— PLAN OF PROPOSED HOUSE —

— ON PLOT N^o 146 - A.3 —— OLD TOWN Q^R. —

Building Completion Report

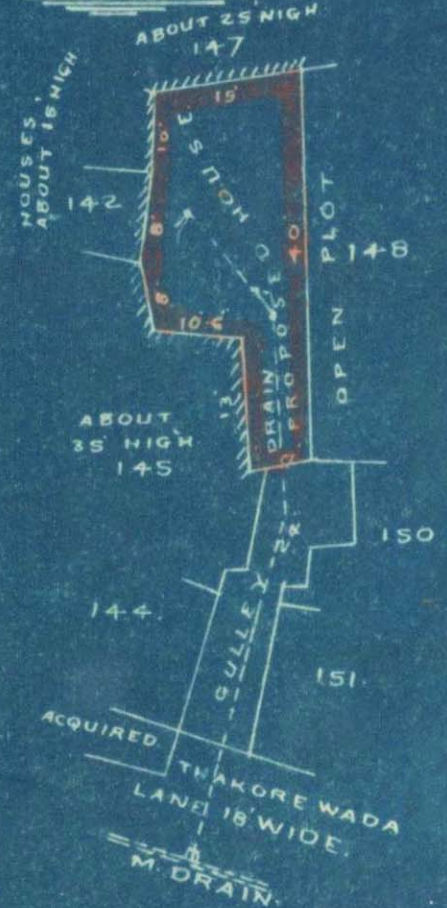
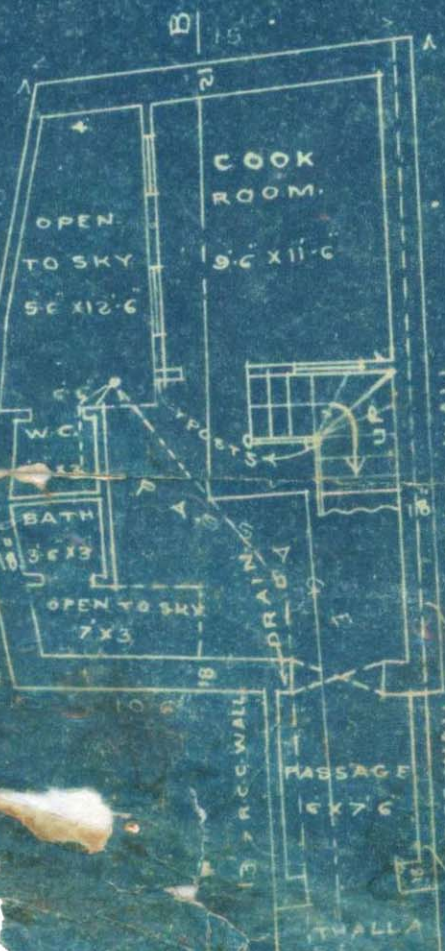
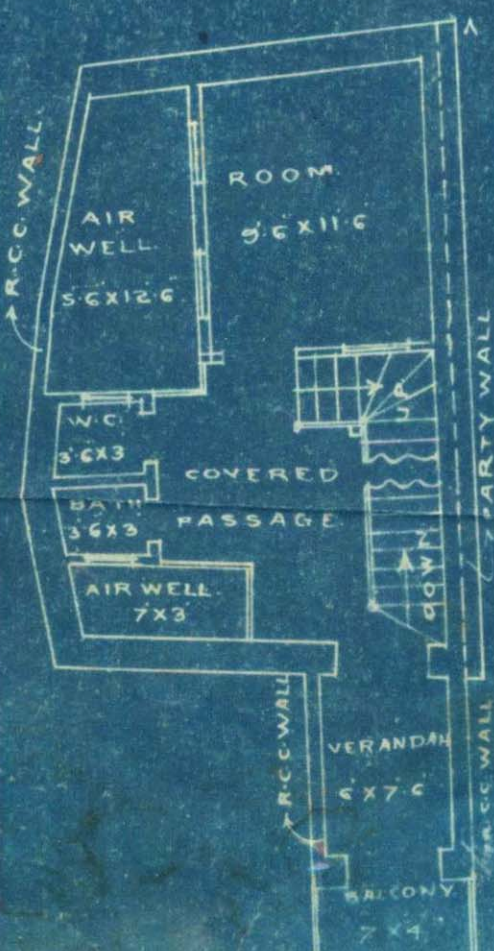
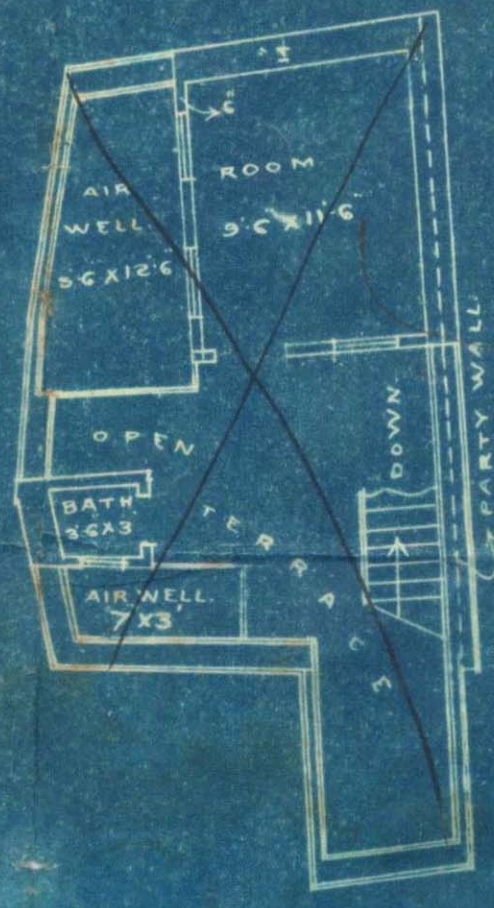
I humbly & respectfully beg to state that air well has
and water closet bath are being constructed. The
about 4 to 5 feet but they only meant for
allow
here-fore request your honour to kindly/me
k.

~~is~~ informed that it is observed that in building~~are~~ his Building on Plot No. 146~~their~~ Survey Sheet A3, O.S. Quarter,~~he is~~ deviating from the approved plan, closing the airwell
~~they are~~ in the middle by roofing, W.C. & Bath on
the ground floor not erected, parapet wall
allround are more than 3' in heightInstructions are therefore given to ~~him~~ them to at once stop the work and
make the building in conformity to the approved plan, or steps will be taken
under the Act.

The airwell is opened from the
top and the parapet wall is 5'
in height but still flooring work
6" to 9" about so be made & then
it will be about 4' or 4.3" about
I think there will be no obj. R.O.

No obj. File
20/1 DB
